PRODUCT CHANGE NOTIFICATION (PCN)

AMJE0909-0100-GNB-24
MODULAR CABLE

CHANGE NOTIFICATION: PCN 20220509_AMJE0909-0100-GNB-24

DESCRIPTION OF CHANGES:
CHANGE OF DATA SHEET
CHANGE OF DATA SHEET
New Draw.-No. ASS_7945_CArev02

AMJE0909-0100-GNB-24 OLD VERSION

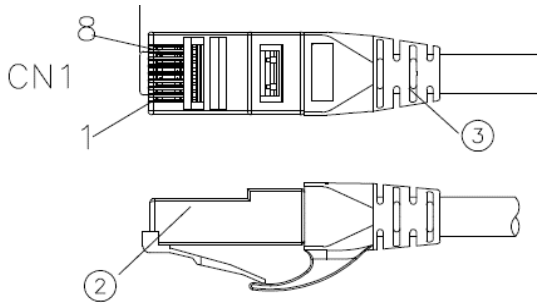
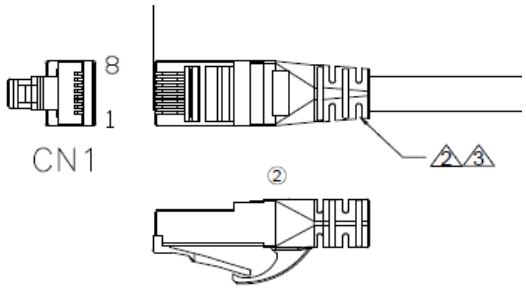
③	Molding	PVC 45P Color: see order code	NA	KG
②	CONNECTOR	RJ45 8P8C two fork Short type 3u" gold plated	2	PCS
①	CABLE	CAT6 UTP (24AWG*1PR)*4+PVC OD=5.8±0.3MM Color: see order code	NA	MM
NO:	NAME	DESCRIPTION	Q'TY	UNIT

3	Molding	PVC 65P Color: see order code ②	NA	KG
2	CONNECTOR	RJ45 8P8C PLUG 3u" gold plated ②	2	PCS
1	CABLE	CAT6 U/UTP (24AWG*1PR)*4+Cross+PVC Jacket OD=5.8± 0.3MM Color: see order code ②	NA	MM
NO:	NAME	DESCRIPTION	Q'TY	UNIT

Drawing-No.
ASS 7945 CA

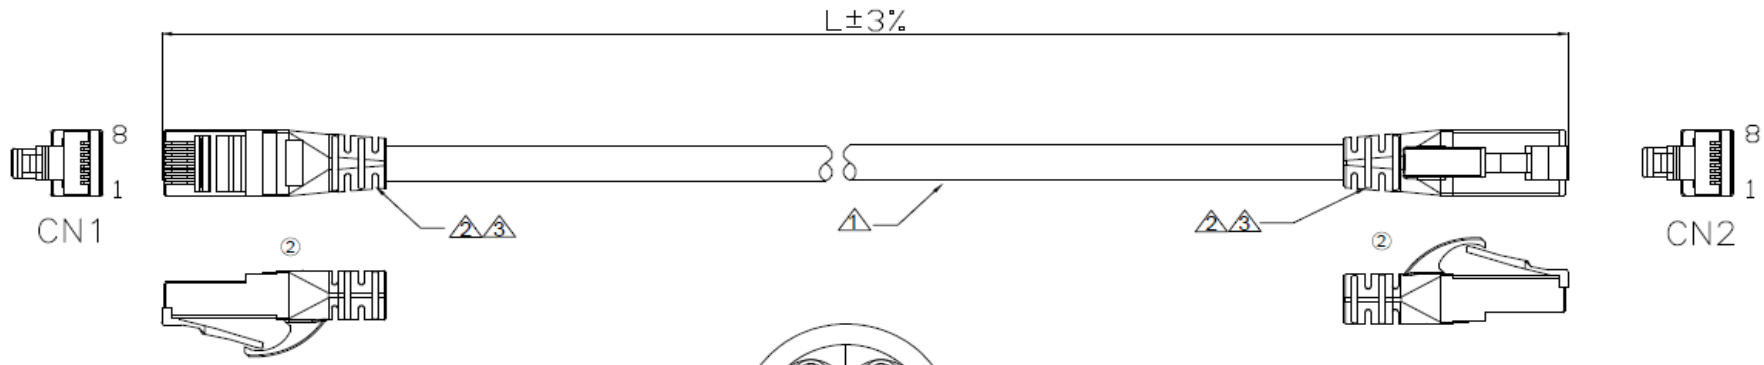
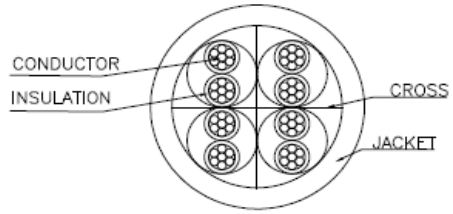
Id.	Modification	Date	Name
②	Change the plant	09.05.2022	Luca
①	Update the WSW order code	02.06.2017	Amy
⓪	Drawn	30.03.2017	Amy

NO:	NAME	DESCRIPTION	Q'TY	UNIT
3	Molding	PVC 65P Color: see order code ②	NA	KG
2	CONNECTOR	RJ45 8P8C PLUG 3u" gold plated ②	2	PCS
1	CABLE	CAT6 U/UTP (24AWG*1PR)*4+Cross+PVC Jacket OD=5.8± 0.3MM Color: see order code ②	NA	MM
